AGENDA

HISTORIC PRESERVATION BOARD MEETING

**STAFF MEMORANDUM
HISTORIC PRESERVATION PROGRAM
PLANNING AND URBAN DEVELOPMENT**

TO: Chair Pollard and Members of the Historic Preservation Board
FROM: Rob Wiener, Historic Preservation Compliance Coordinator
DATE: October 28, 2022
RE: 1 Commercial Street – PUBLIC HEARING – Re-Approval of Expired Certificates of Appropriateness for Storefront Replacement and Upper Floor Rehab and Dormers
PROJECT ID: HPBR-002193-2022 (Plans Identical to HPBR-000687-2019, HPBR-000836-2019)
MEETING: November 2, 2022

Owner	
Prepared For:	
Consultant:	
Architect: ARCHETYPE architects 48 Union Wharf Portland, Maine 04101 (207) 772-6022 ARCHETYPE@ARCHETYPEPA.COM	
Project: 1 COMMERCIAL ST SHELL IMPROVEMENTS Portland, Maine	
Revisions:	
Date: 25 SEP 2019	Scale: As indicated
ELEVATIONS	
A2.01

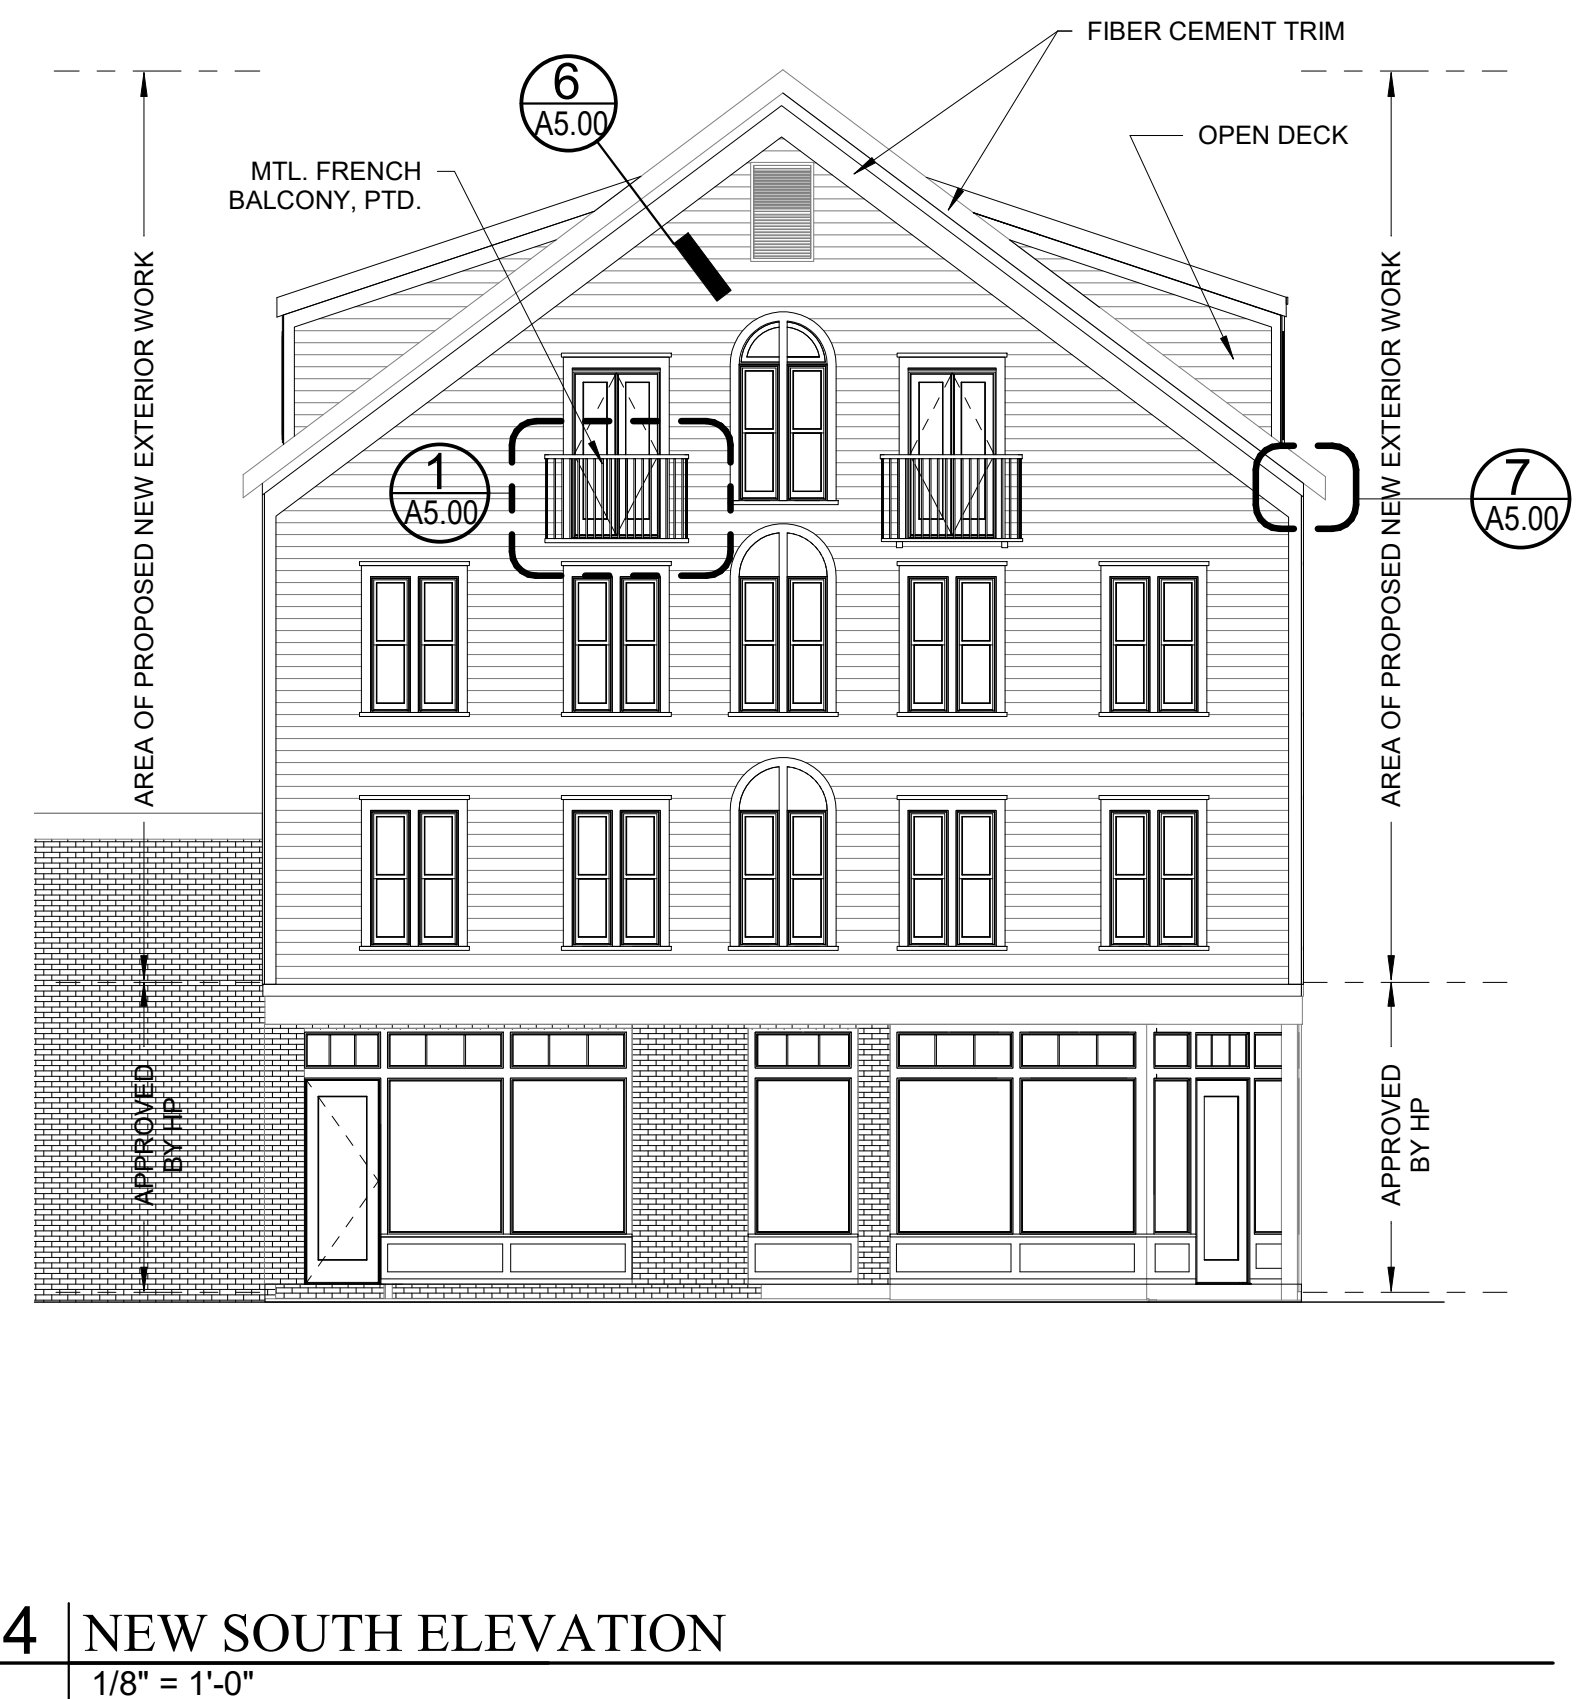
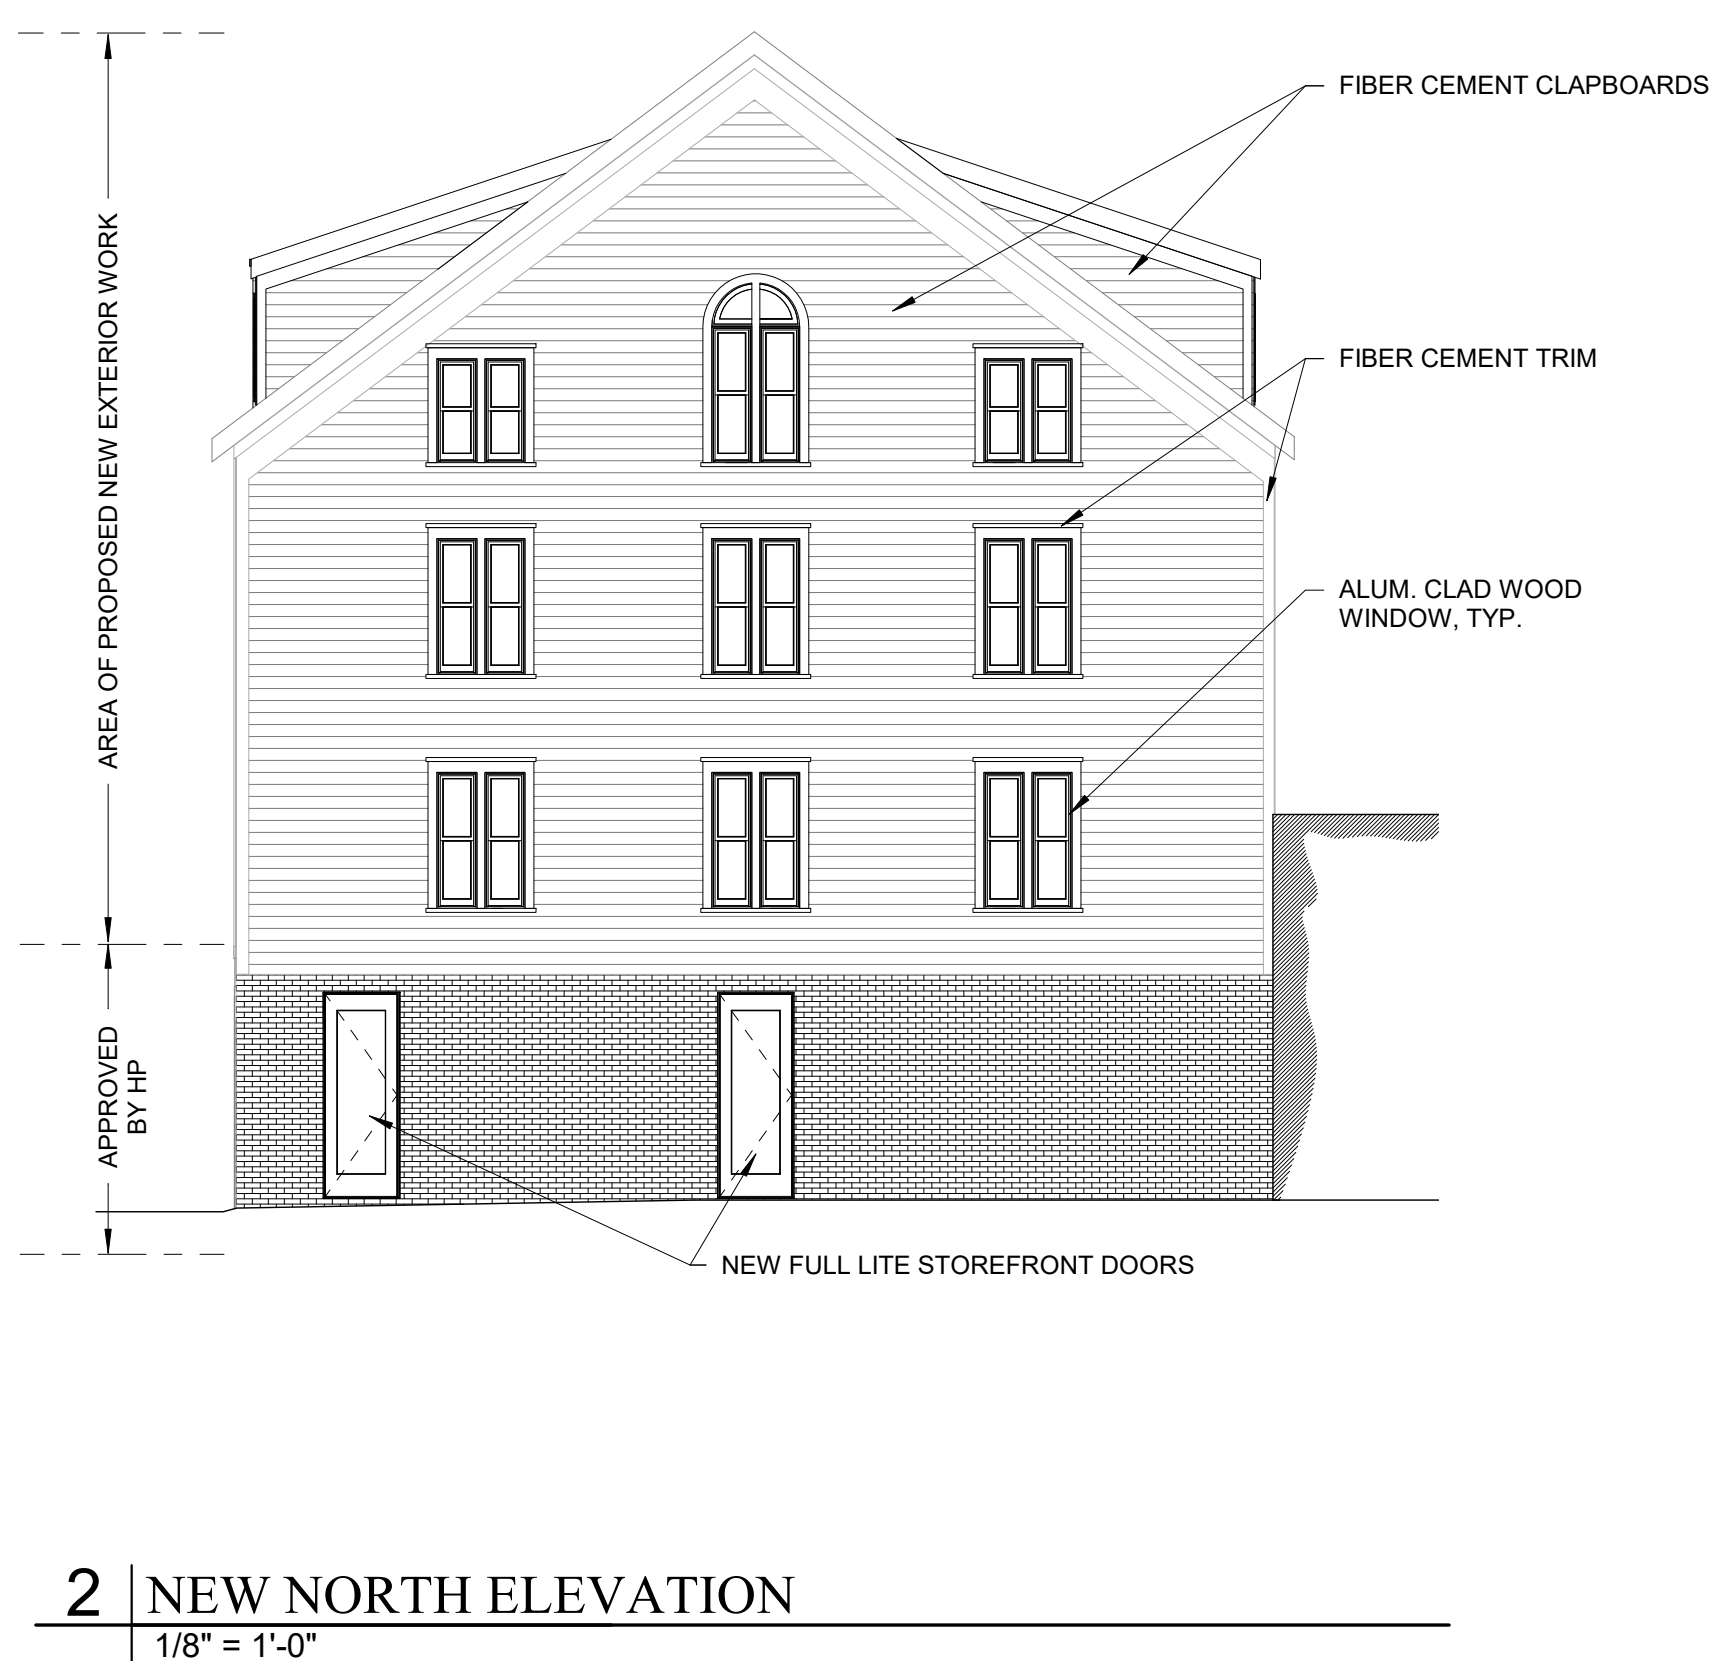
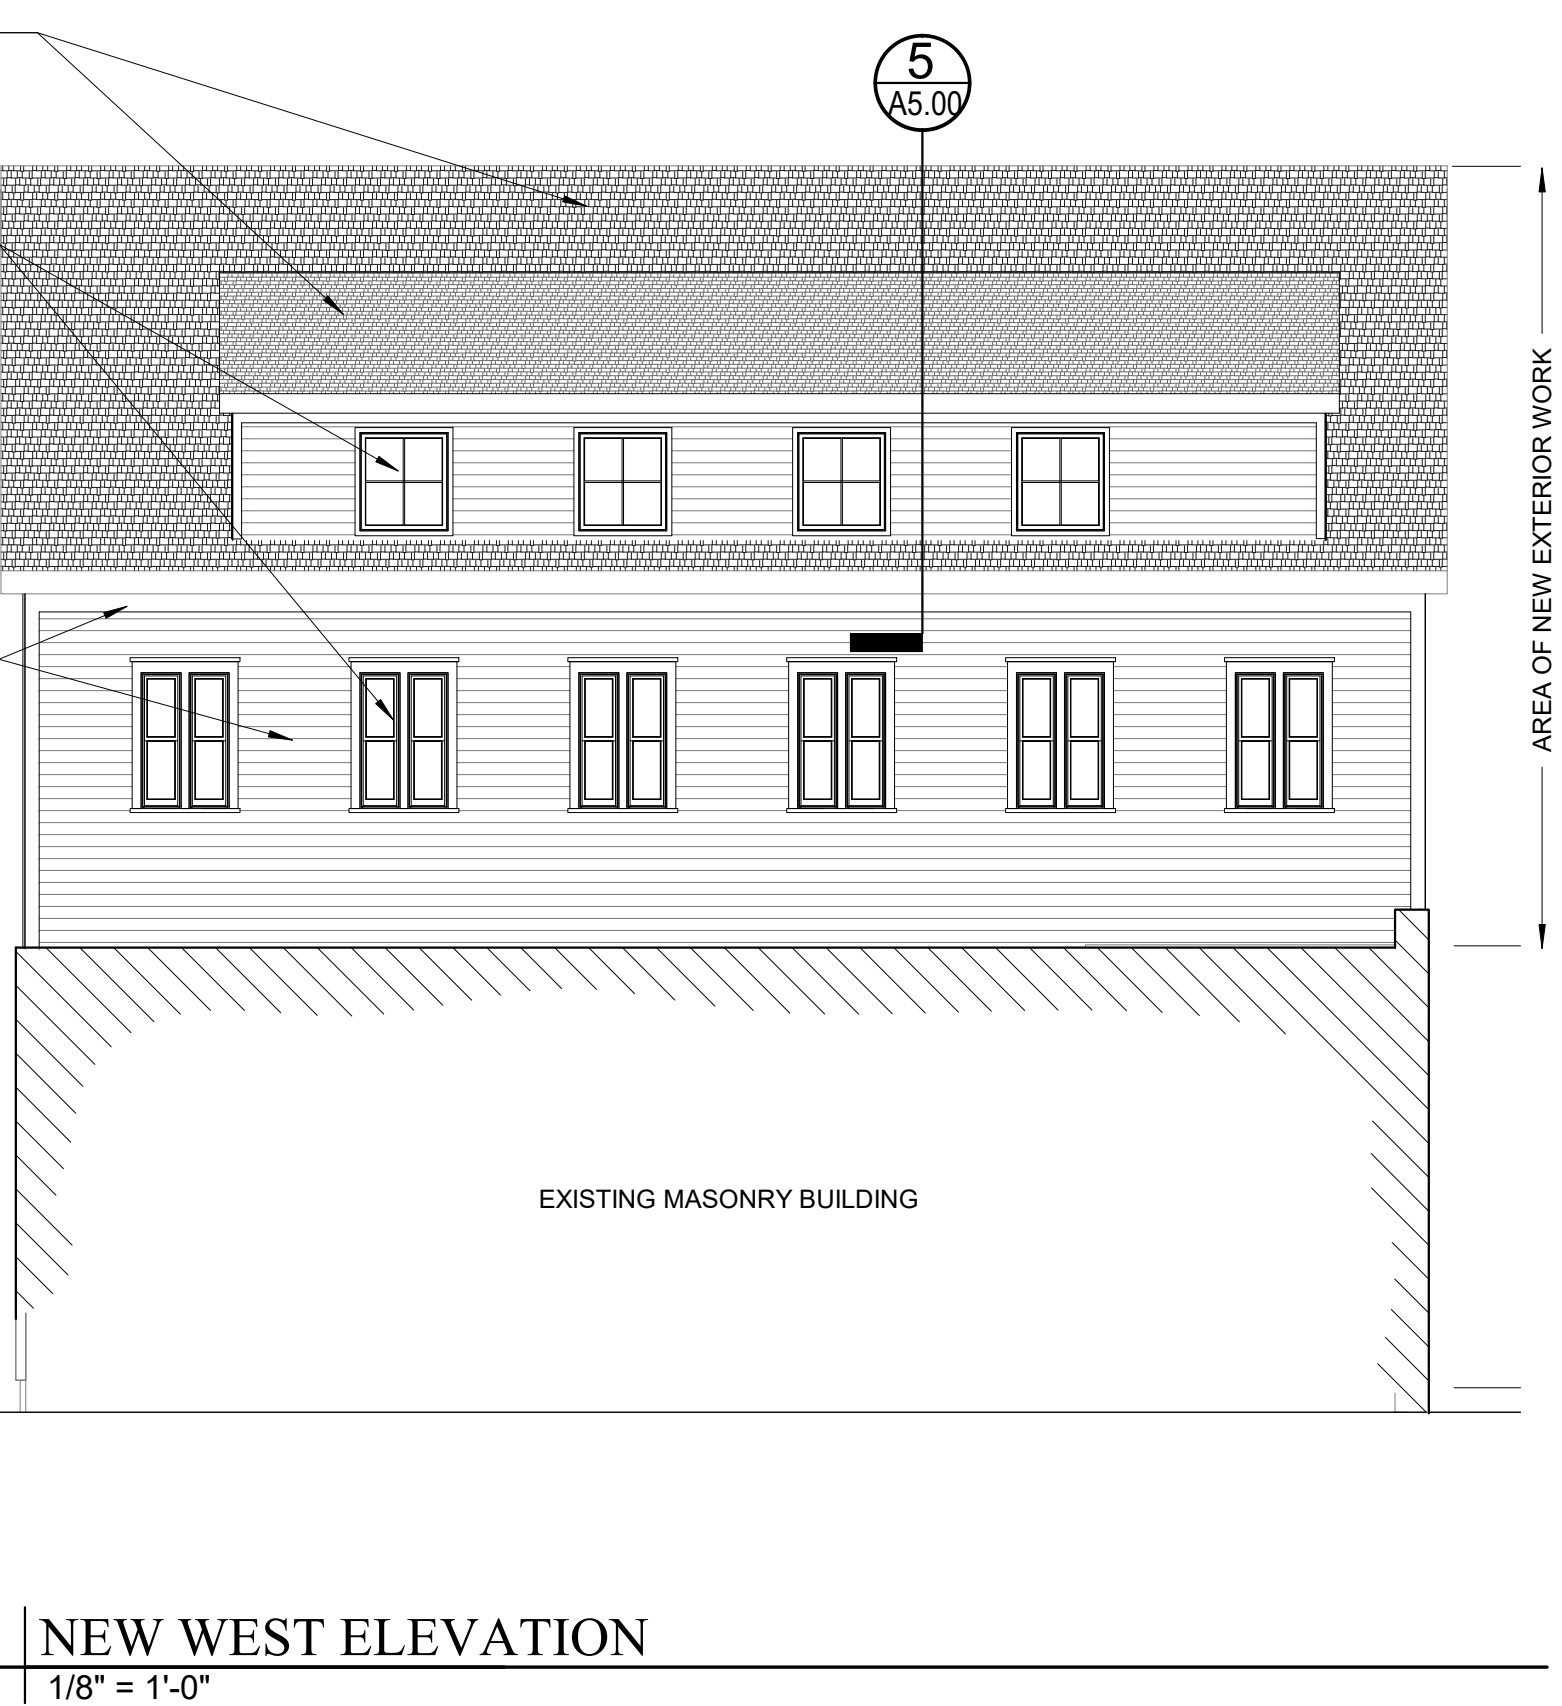
- The west dormer allows the primary roof to be dominant. The trim details shown on the details page (A5.00) – flat fascia with a shadow board – are not reflected on the elevations. In their past comments Board members encouraged the architect to employ enough detail to convey a simple historic style.
- Window type and layouts are regular, well-proportioned and similar in appearance to the predominant type in 1924.

Other questions remain for the Board, on whether desired features like the east inverted dormer, the balcony, and modern alternative materials can be judged to be compatible modern interventions.

- The new design for the east dormer bears much greater similarity to the west dormer than before, and with closed end walls, regularly spaced posts, finished surfaces on the interior, and a simple shed roof and trim detailing, it may soften the impact of the interruption in the roof. In appearance the new approach seems a quiet treatment for a modern cut into a prominent roof plane.
- Mr. Lloyd's new approach to the balconies on the south end (two shallow, light-weight metal balconies instead of one long one) is less obtrusive than before, but

- Finally, some Board members may be uncomfortable with the proposed use of fiber-cement clapboard siding to replace the existing wood clapboard. The general guideline adopted by the Board for replacement of wood siding would typically specify wood replacement clapboard; the Board might consider waiving the guideline with this project where fiber-cement is proposed for the upper stories of a downtown commercial building.
